Addendum No. 3

Project: 2018 Physical Education Facilities
North Harrison Middle School
Ramsey, Indiana

Proj. No: 1518.03

Date: December 12, 2017

A. **Provide products of A. Johnson Controls****Drawings****1. G-101: Life Safety Plan**

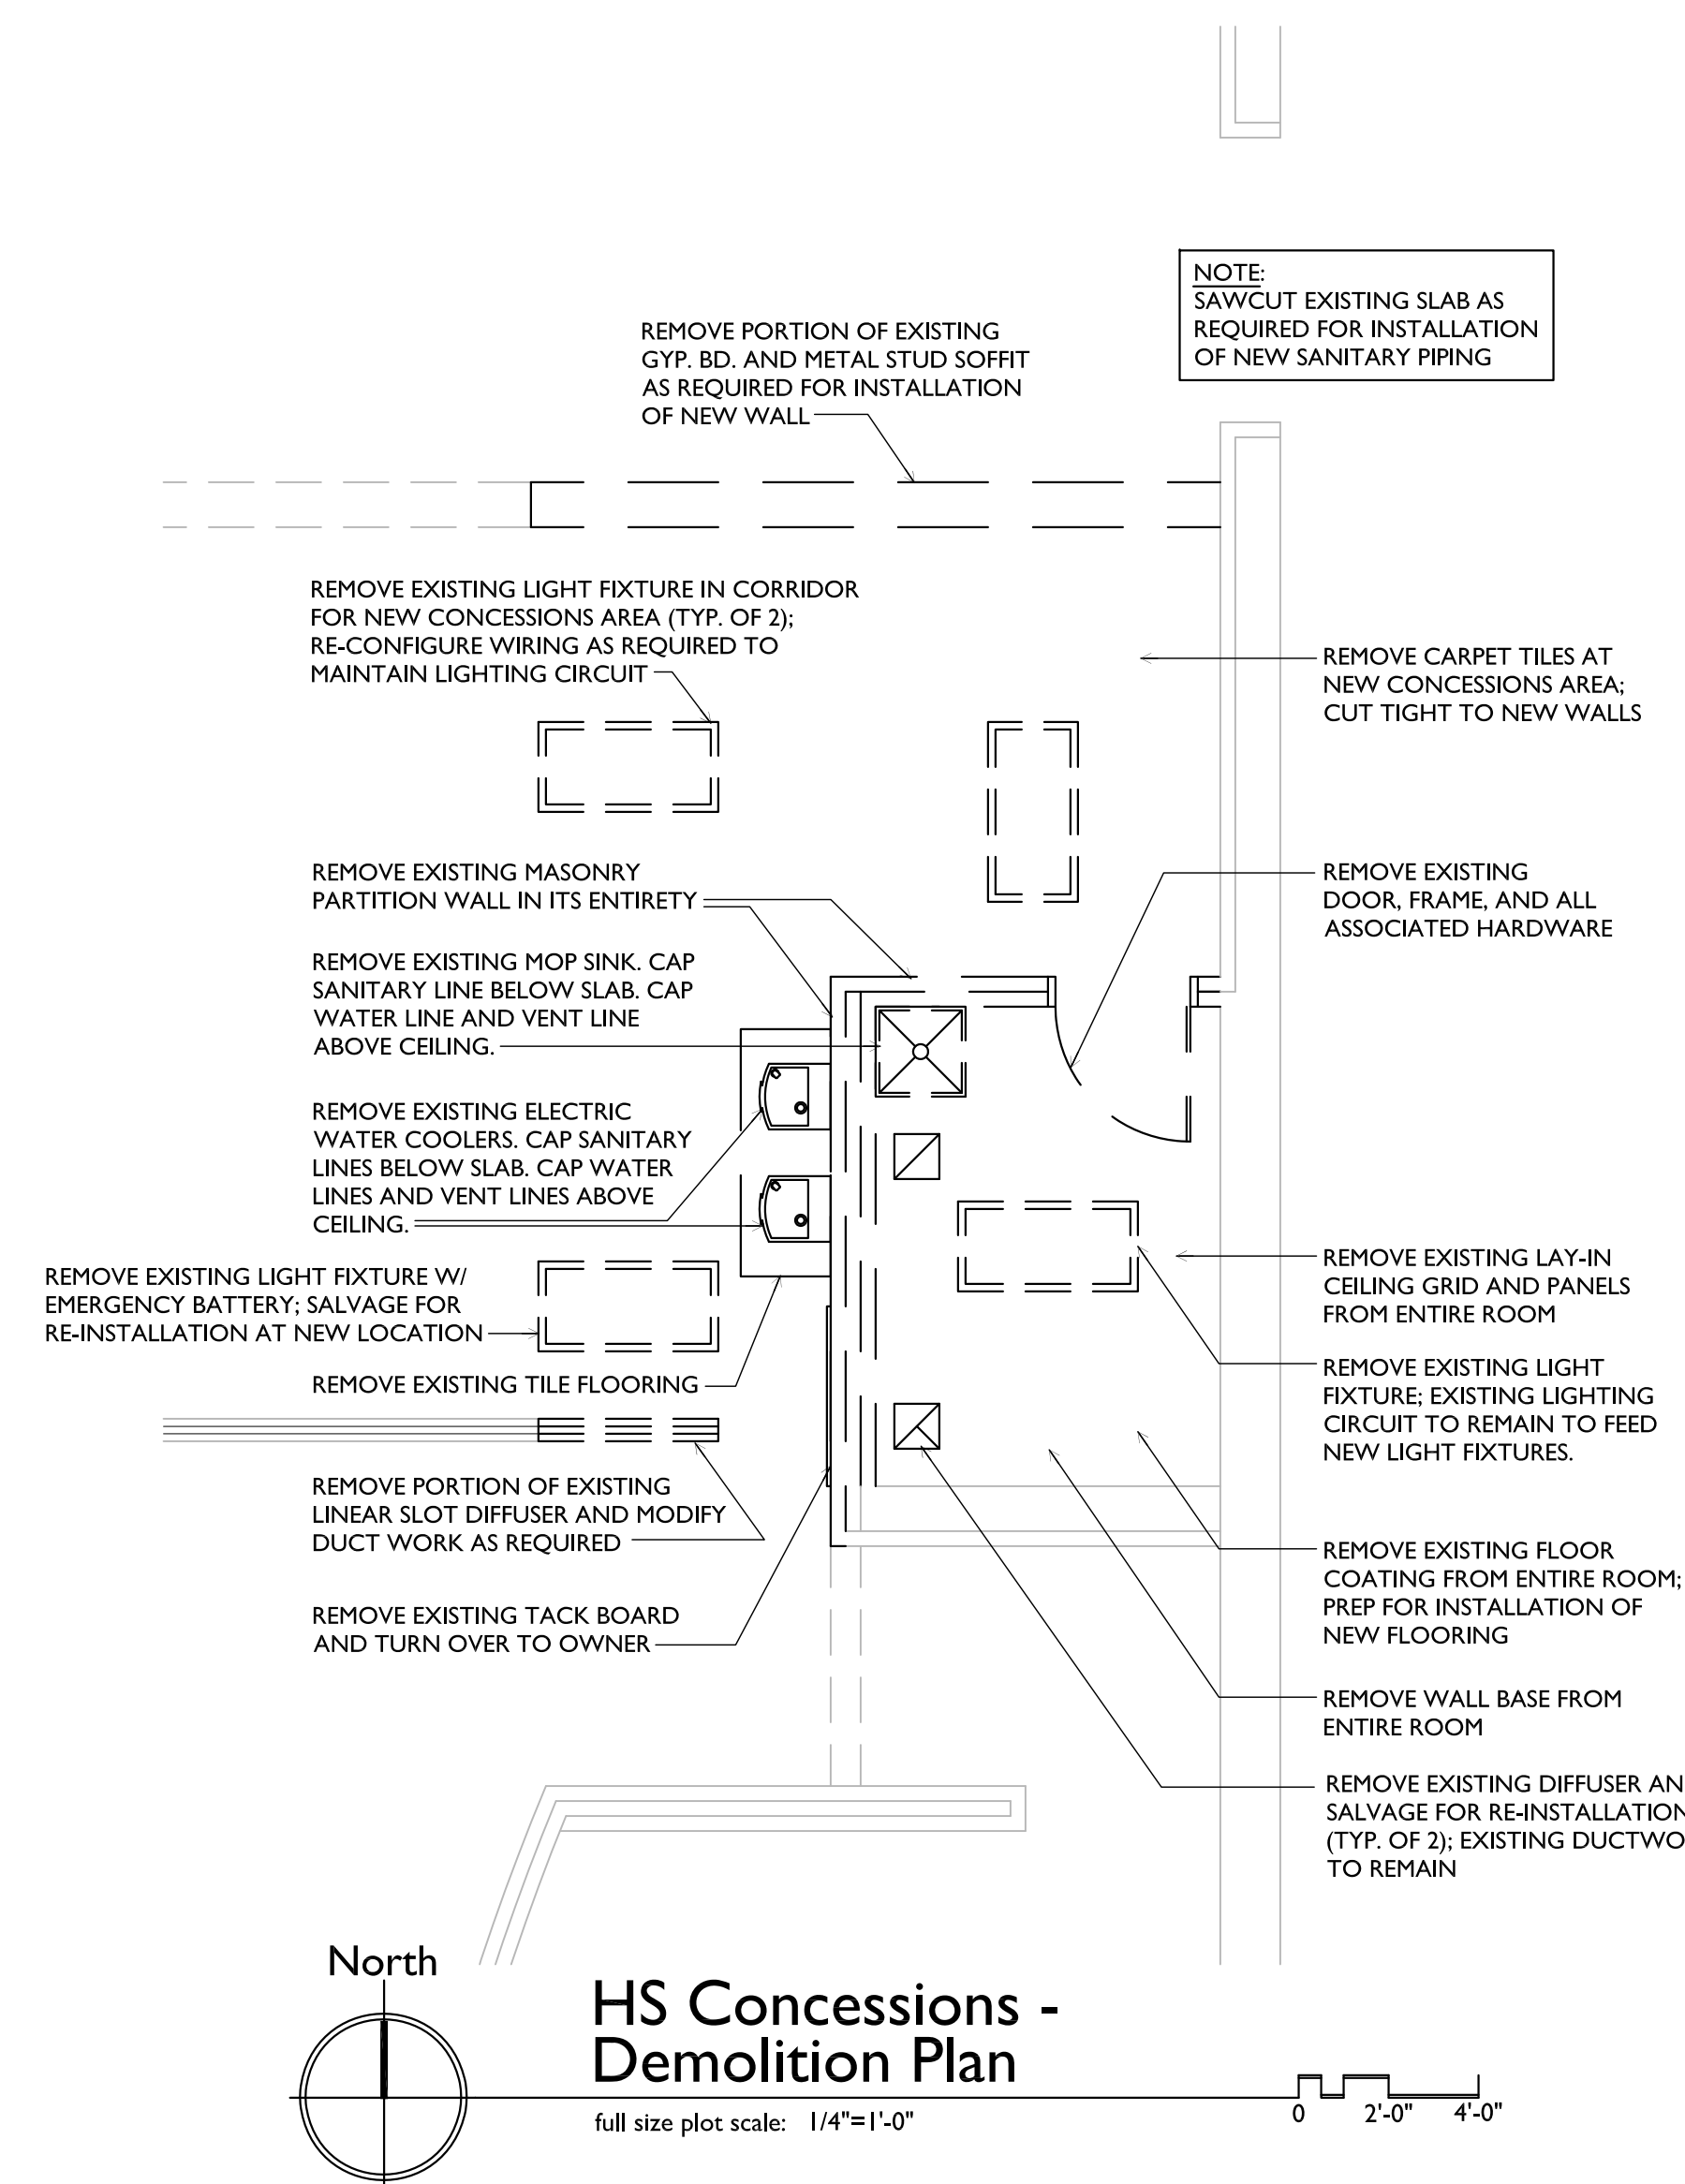
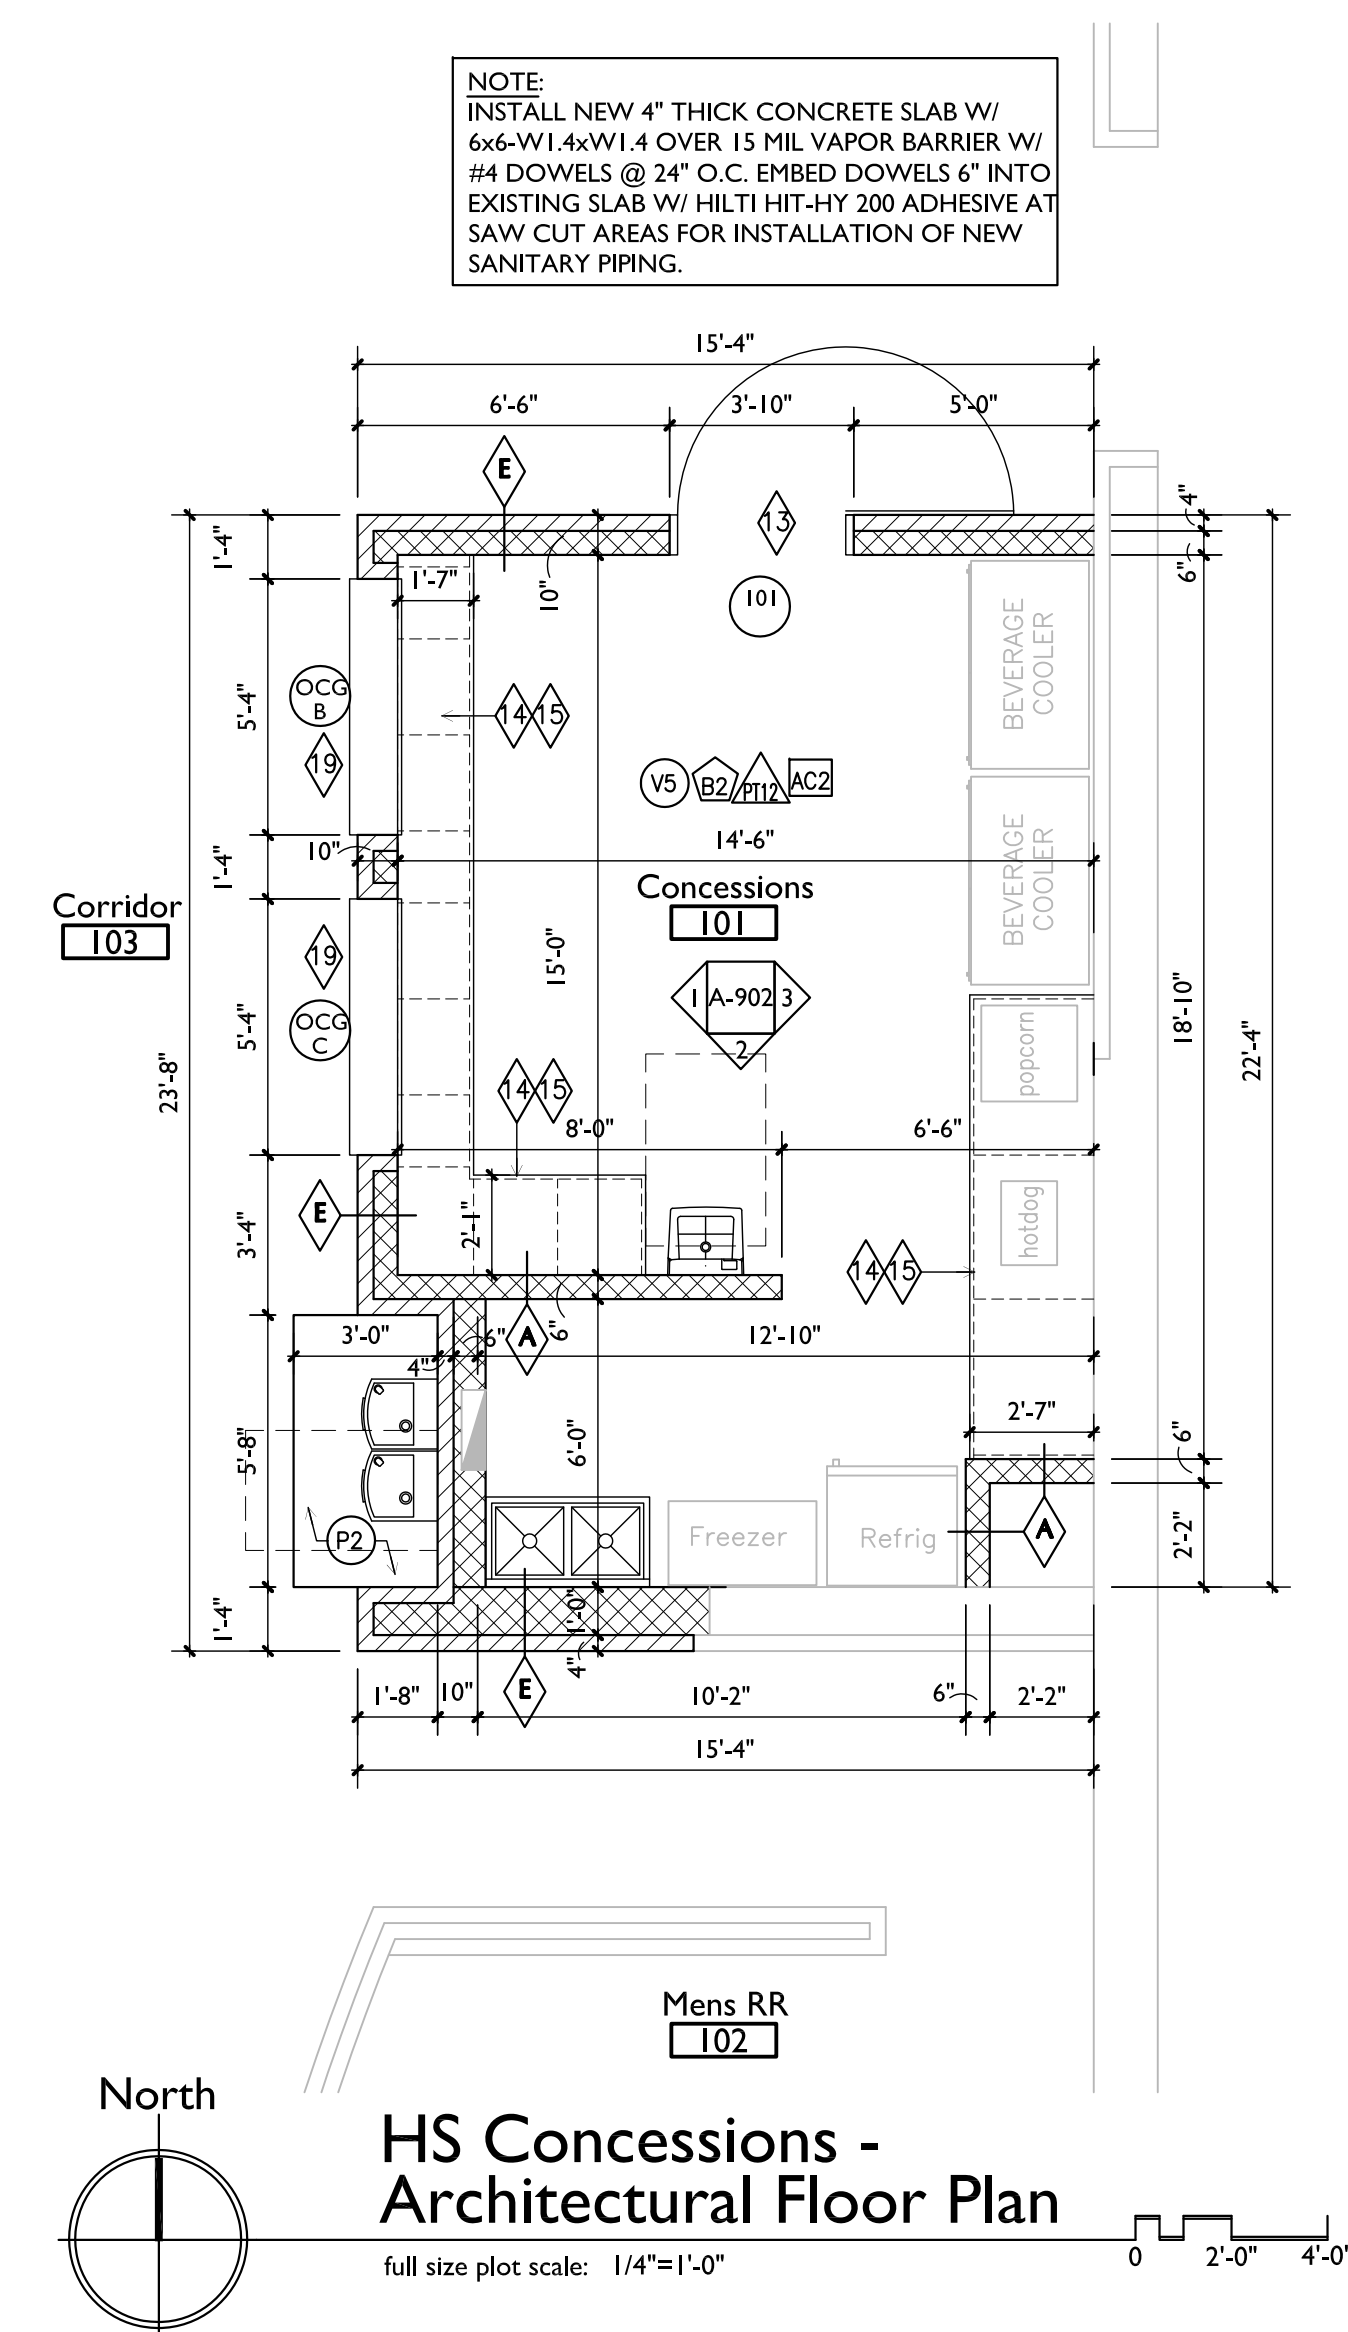
The Code Summary Table floor areas of the Middle School & High School were combined. A revised table is included with this addendum in drawing AD3-1.

AREAS FOR MIDDLE SCHOOL AND HIGH SCHOOL WERE COMBINED
IN THE CODE SUMMARY TABLE ON SHEET G-101. ABOVE ARE THE
CORRECTED AREAS PER BUILDING.
